CORRECTIVE MEASURES IMPLEMENTATION PLAN SOLID WASTE MANAGEMENT UNIT  
54 WITH TRANSMITTAL AND RESPONSE TO COMMENTS NAVAL ACTIVITY PUERTO  
RICO  
6/1/2012  
AGVIQ/CH2M HILL

RE: Contract No. N62470-08-D-1006  
Task Order No. JM04  
Solid Waste Management Unit (SWMU) 54  
Naval Activity Puerto Rico - Ceiba, Puerto Rico  
Corrective Measures Implementation Plan for SWMU 54 Benzene and Ethylbenzene Plume

<b>Responses to Comments Summary</b>	
<b>Regulatory Comments from:</b>	Timothy R. Gordon (EPA Project Coordinator), Robert Young (TechLaw, Inc.), Wilmarie Rivera (PREQB Federal Facilities Coordinator)
<b>Document:</b>	<i>Corrective Measures Study Addendum SWMU 54 Benzene Plume and the Corrective Measures Implementation Plan SWMU 54 Benzene Plume, Naval Activity Puerto Rico (NAPR), EPA ID PR2170027203, Ceiba, Puerto Rico, dated January 2012</i>
<b>Regulatory Letter Date:</b>	Email Dated: March 30, 2012
<b>Response Due Date:</b>	June 18, 2012
<b>Response Submittal Date:</b>	June 18, 2012

**FIGURE 2-1**  
Benzene Concentrations Exceeding Corrective Action Objective August 2009 Through October 2010  
SWMU 54  
Naval Activity Puerto Rico

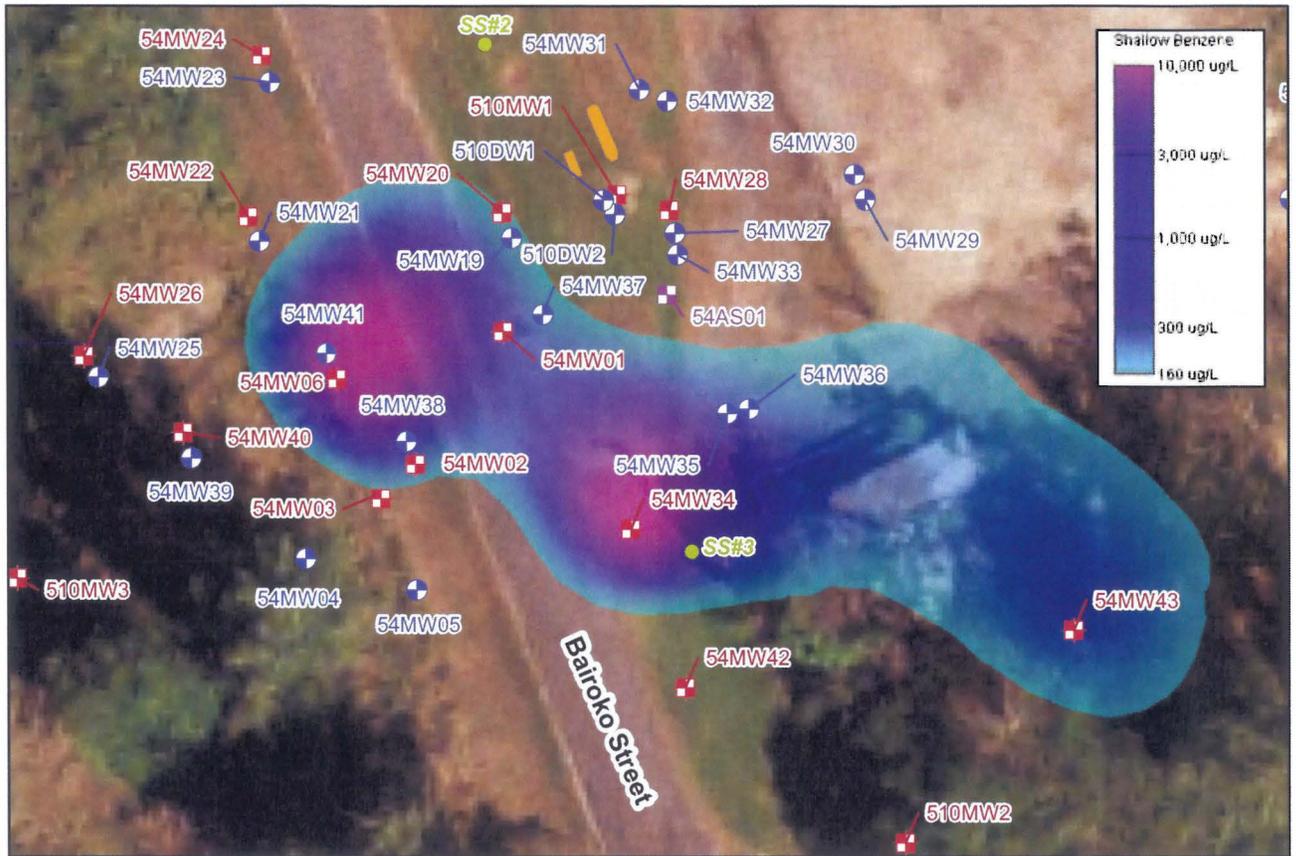
1. Page 1-6, Section 1.2, Bullet 2: Please clarify that when referring to VOC concentrations observed, it is referring to VOC air monitoring at the storm sewer monitoring location SS#3. Also, the storm sewer monitoring locations should be depicted in a Figure.

The text (now on Page 1-8, Section 1.3, Bullet 1) was adequately clarified. Please notice that the vapor monitoring locations were added to Figure 1-4 instead of Figures 3-1 and 3-2. Actually, there are no Figures 3-1 and 3-2 on the current version of the document.

The text has been clarified to indicate that observed VOC concentrations are those observed at underground utility structures. Vapor monitoring locations (SS#1, SS32, SS#3) were added to Figure 3-1 and 3-2.

Comment acknowledged.
